**RCRBD Record
Set T.C.**

Liquid Unit Location – Twin Enviro Services, Milner, CO

PJ3967-1
Fire Prevention
In: 01/23/2020
Out: 01/27/2020

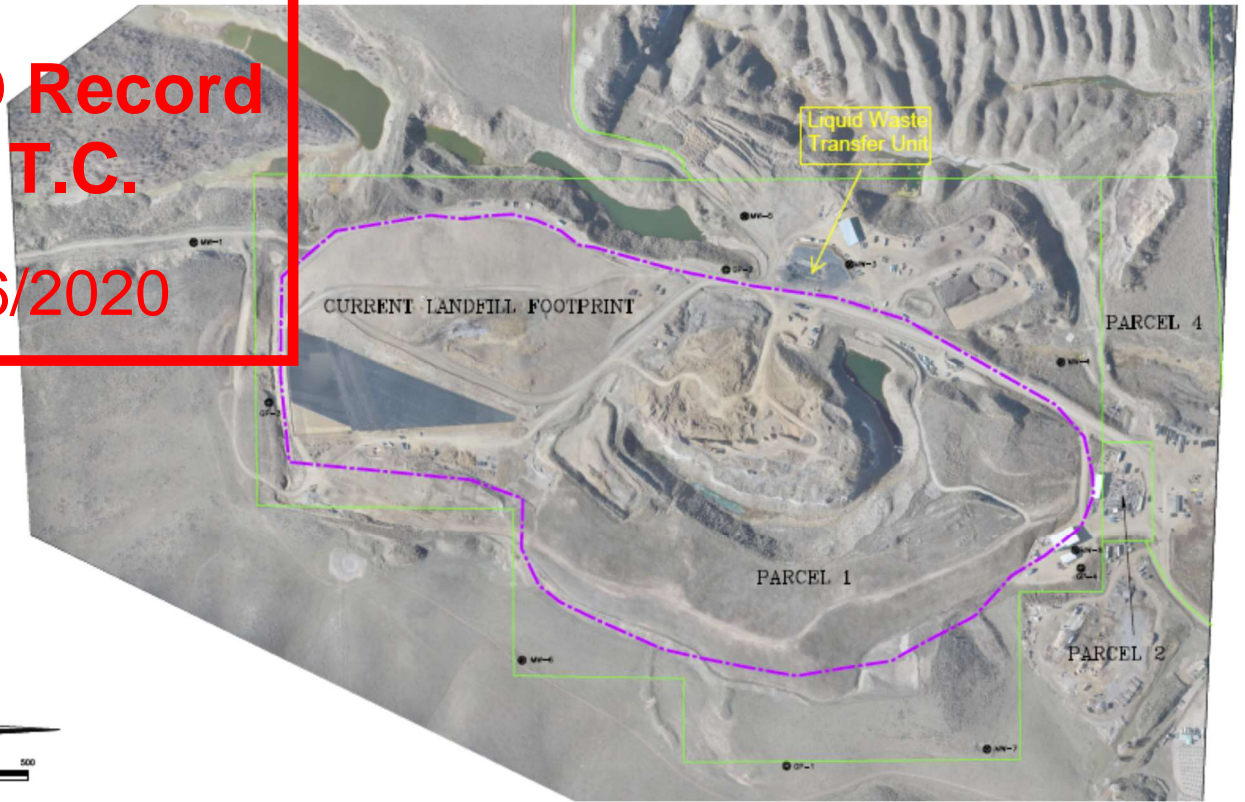
provide sign that identify the contents.
USED COOKING OILS
